Central Planning Authority

Minutes of a meeting of the Central Planning Authority held on December 15, 2021 at 10:00 a.m. in 2nd Floor Conference Room at Governor's Square.

CPA/26/21

Figure 1. The habitat present at the site (outlined in light blue), indicating mangroves along the southern boundary.

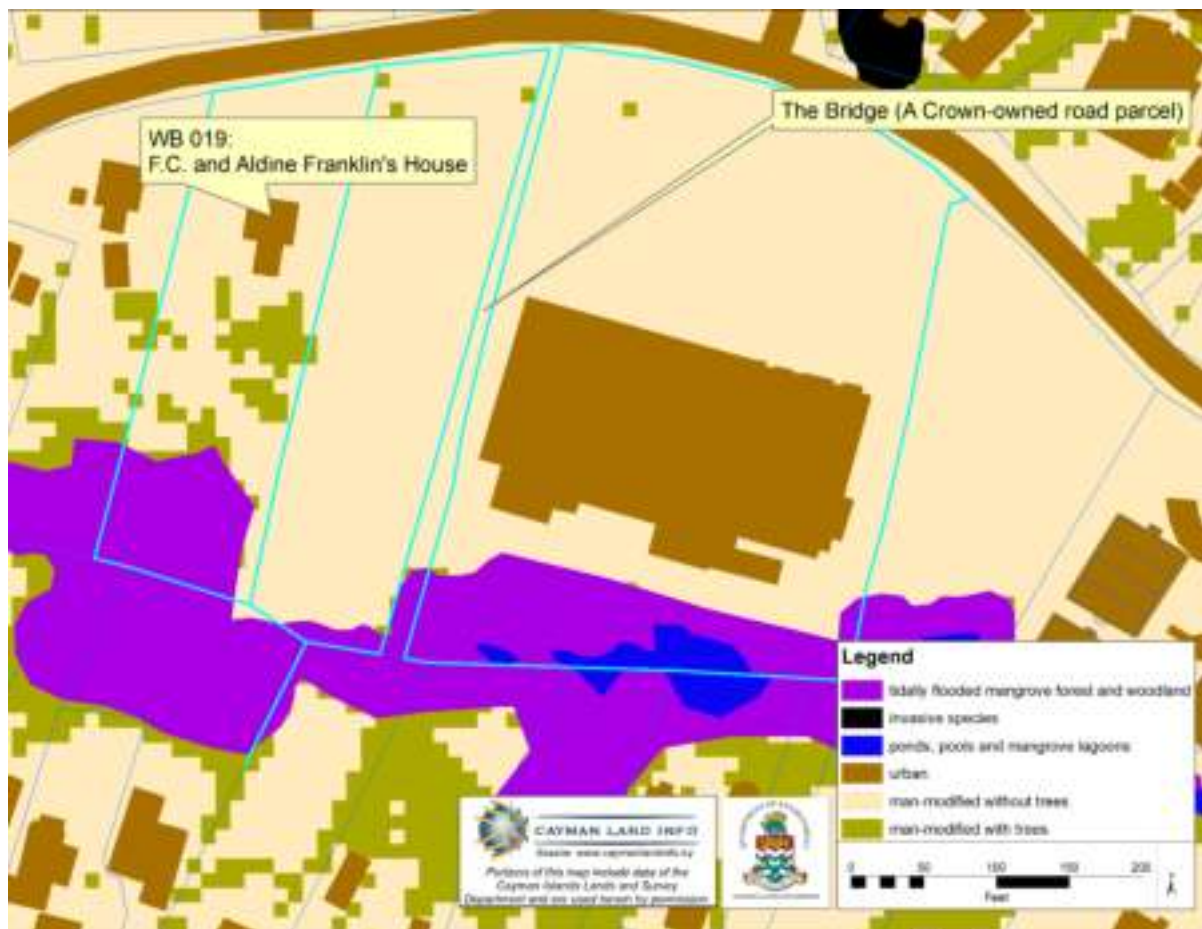
There is primary habitat along the southern boundary of the site, which is seasonally flooded mangrove forest (see Figure 1). Mangroves are a Schedule 1 Part 2 Protected Species under the National Conservation Act 2013 and there is an adopted Mangrove Conservation Plan (2020).

We recommend the retention of mangroves where possible. We note that the Applicant is proposing to keep the mangroves behind the existing supermarket, but is proposing to clear, fill and use the area of mangroves to the west, however the purpose is not outlined on the map – it may be recycling or storage. It is recommended that this area be retained as mangroves, which can also assist with drainage. As shown in Figures 5 to 8, the area with the existing mangroves is low-lying and is likely providing stormwater drainage for the area.

Figure 1: DOE's 2013 habitat map extract showing application site outlined in red.

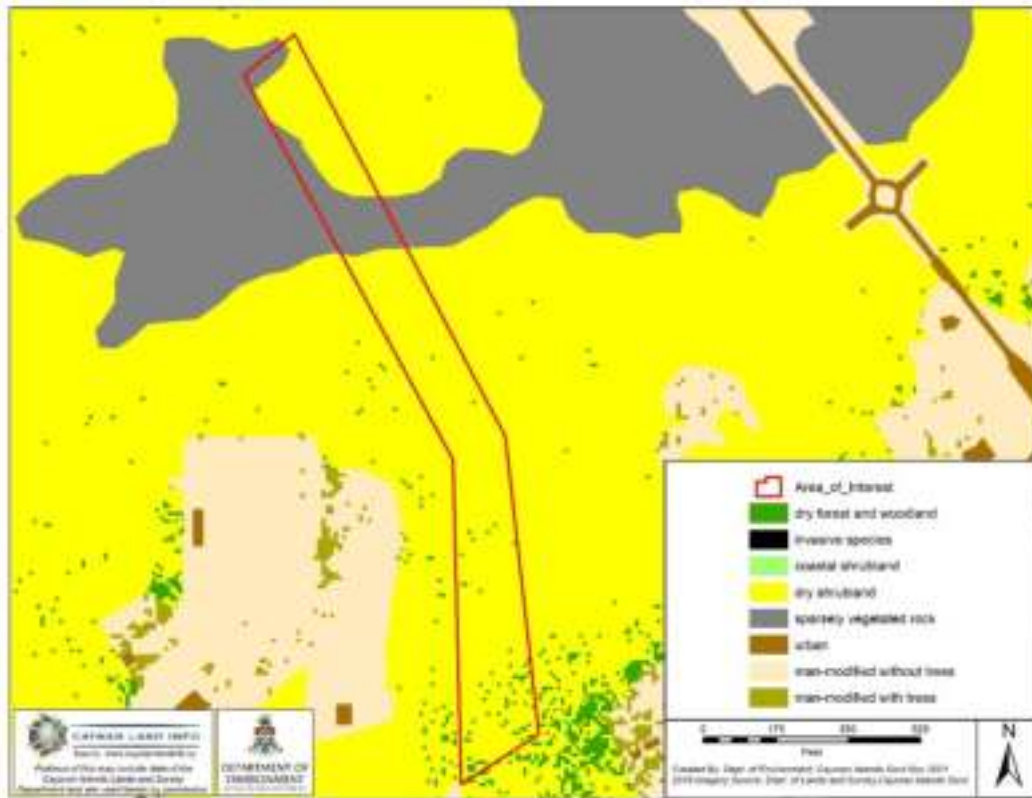
The application site consists of primary habitat - dry shrubland vegetation and sparsely vegetated rock, as shown in Figure 1.

We note that the application site was previously the subject of planning application (Planning Ref: P19-0458) for a smaller scale subdivision of 5 lots, which was granted planning permission on 31 July 2019. Whilst the application site has already been approved for a subdivision, the Department questions the need for another residential subdivision that results in the clearing of primary habitat. Primary habitat is in severe decline and becoming a scarce and highly threatened resource as a result of land conversion for human uses.
